ADDENDUM

Date Issued:	Jan 8, 2025
Project:	Intermountain Health RAD Room Remodel 3741 West 12600 South Riverton, Utah 84065
Addendum Number:	2

Intermountain Health
Riverton Hospital
Radiology Room Remodel

NJRA Project # 24230.00
Construction Documents Oct. 25, 2024
1 Addendum #01 Jan 7, 2025
2 Addendum #02 Jan 8, 2025

Demo and
New
Reflected
Ceiling Plan
Level 1
A112

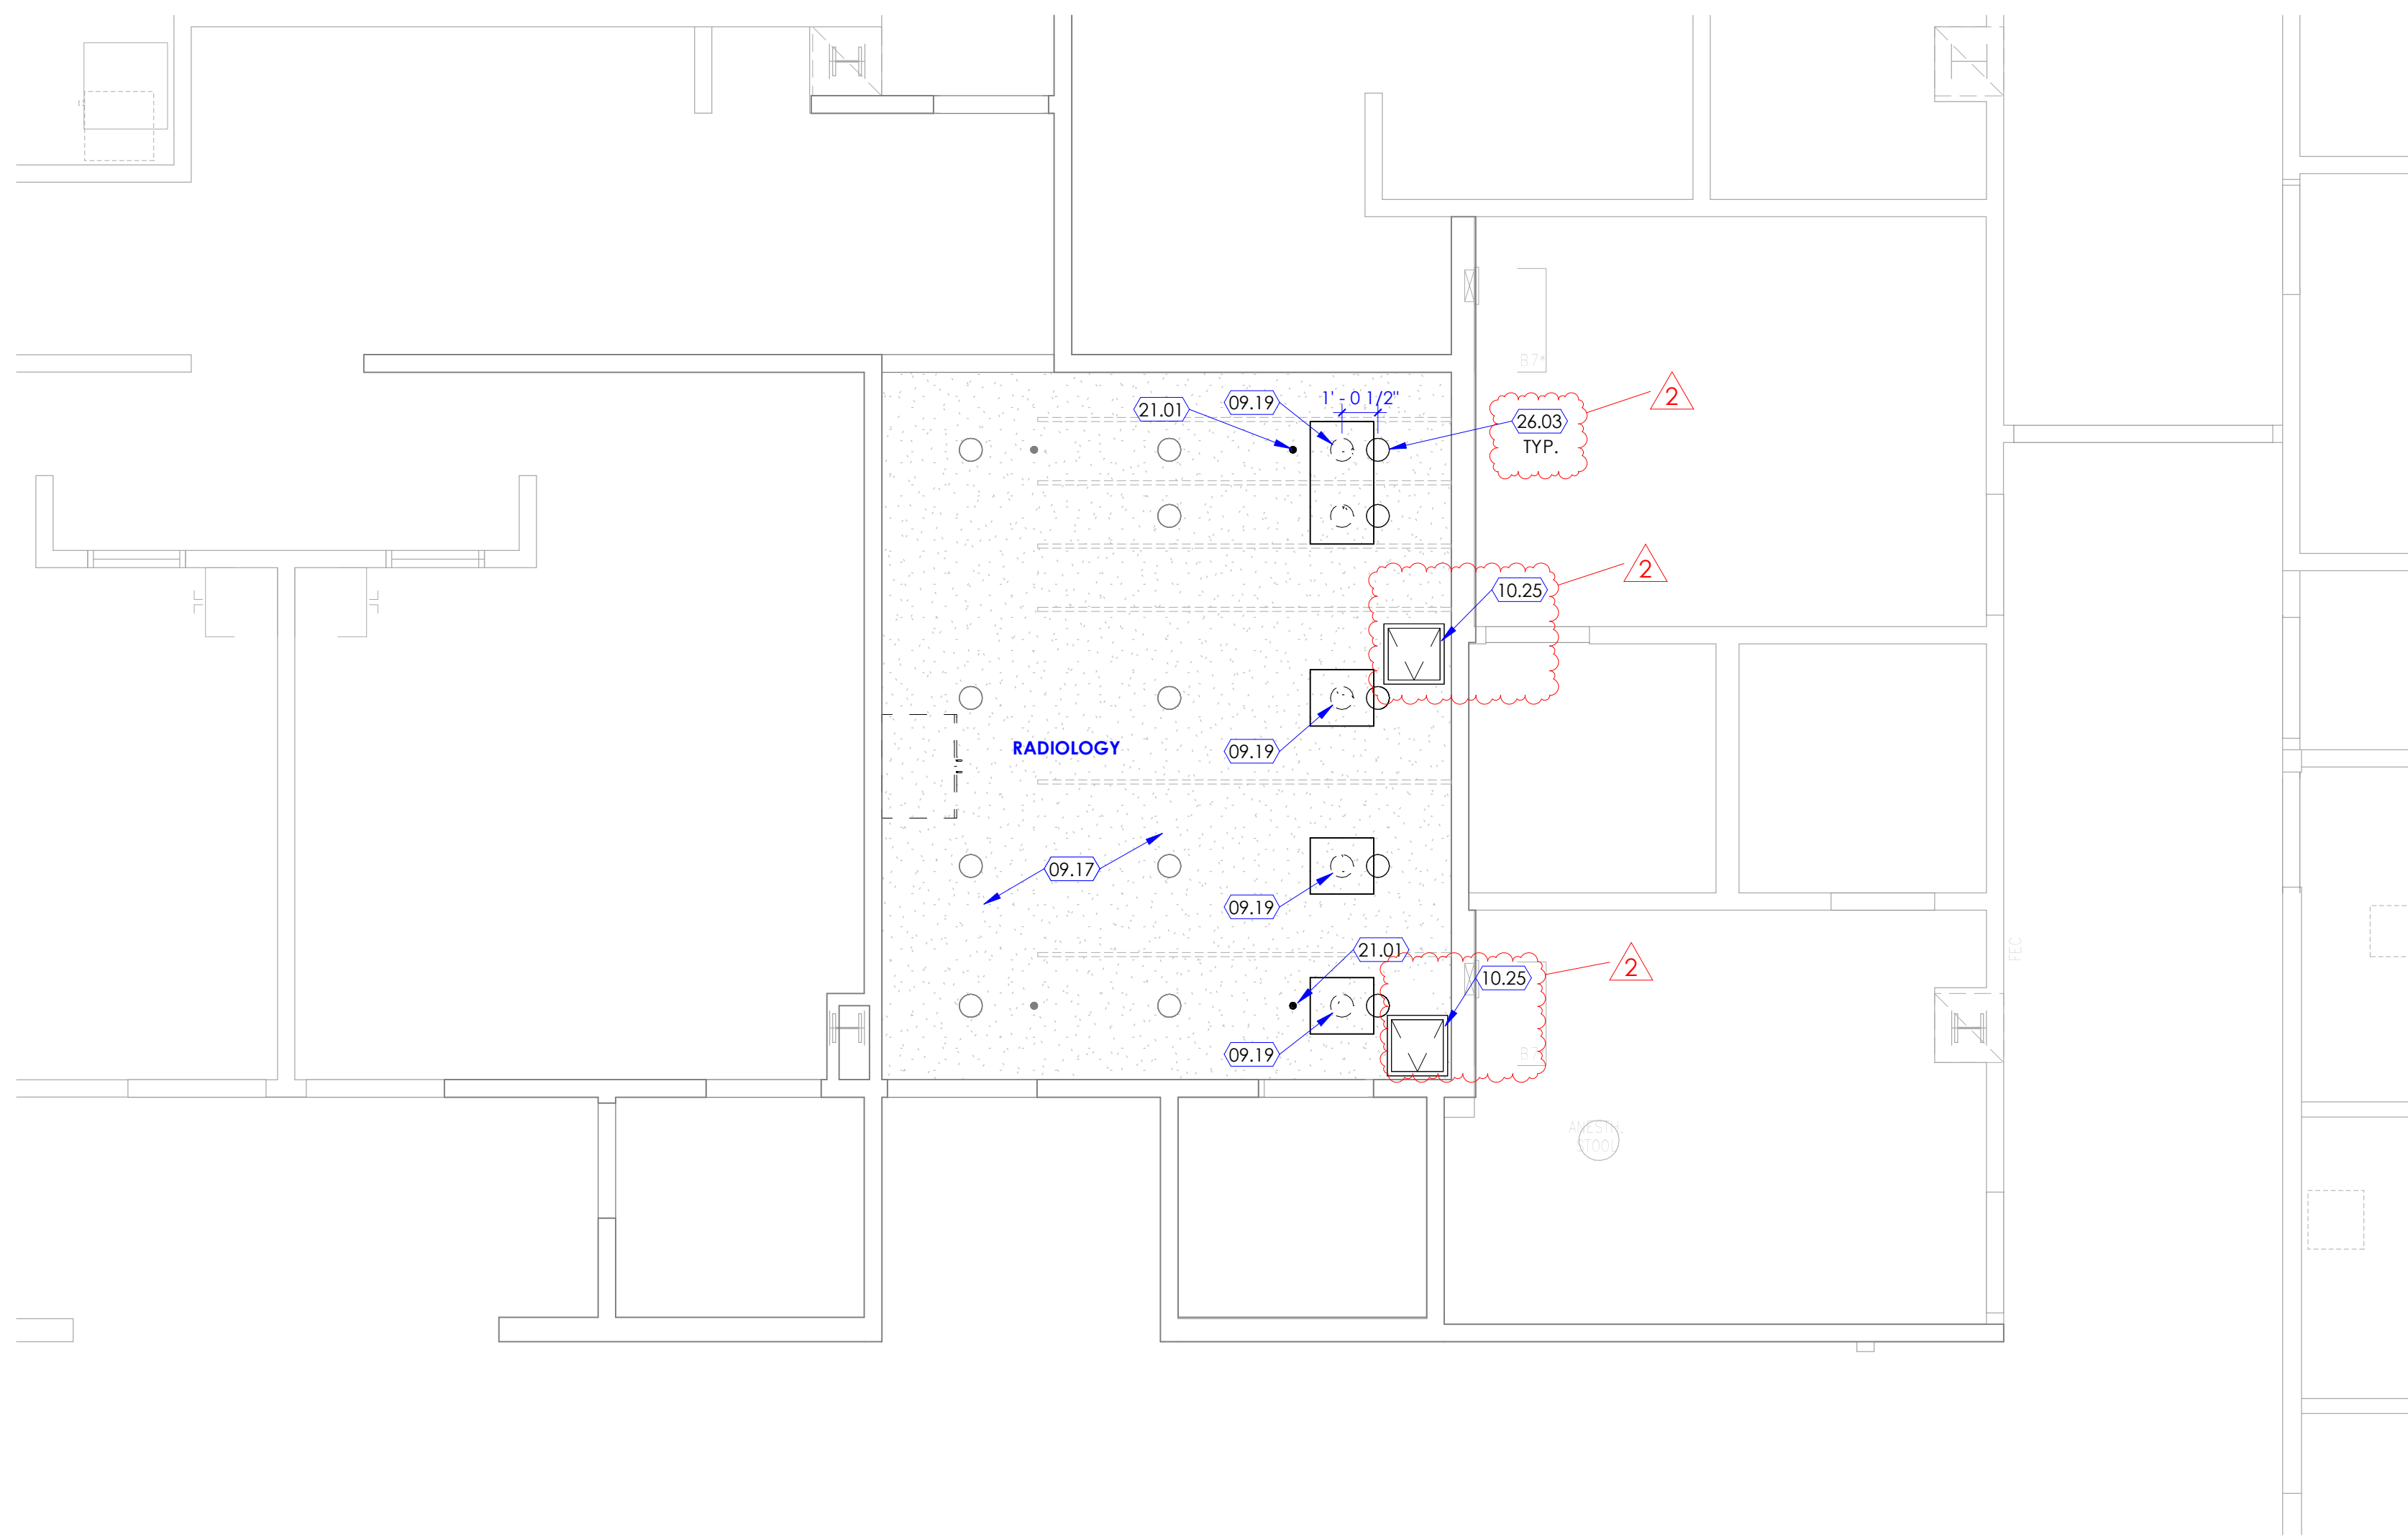
Sheet Number	Drawings
Architectural Drawings	
A112	Edit keynotes 10.25 and 26.03 as indicated.

- 02.02 DRYWALL, EXISTING TO BE REMOVED AS REQUIRED.
02.21 ACCESS PANEL, EXISTING TO BE REMOVED AND RELOCATED.
02.25 UNISTRUT X-RAY TUBE MOUNTING ASSEMBLY, EXISTING TO REMAIN.
02.32 LIGHT FIXTURE, EXISTING TO BE REMOVED.
09.17 PAINT, PAINT ENTIRE CEILING TO MATCH EXISTING COLOR.
09.19 PATCH DRYWALL, RELOCATE LIGHT FIXTURE PENETRATION AS REQUIRED. COORDINATE WITH VENDOR EQUIPMENT. PATCH DRYWALL AS REQUIRED. SEE VENDOR DRAWINGS. SEE ELECTRICAL DRAWINGS.
10.25 ACCESS PANEL, REUSE FROM PREVIOUS DEMO PHASE. COORDINATE EXACT LOCATION WITH VENDOR EQUIPMENT. SEE VENDOR DRAWINGS. RELOCATE SUCH THAT ABOVE CEILING SERVICE IS STILL ACCESSIBLE VIA ACCESS PANEL.
21.01 FIRE SPRINKLER HEAD, EXISTING TO BE RELOCATED. RELOCATE FIRE SPRINKLER HEAD AS REQUIRED.
26.03 LIGHT FIXTURE, REMOVE AND REPLACE EXISTING LIGHT FIXTURES. SEE ELECTRICAL DRAWINGS.
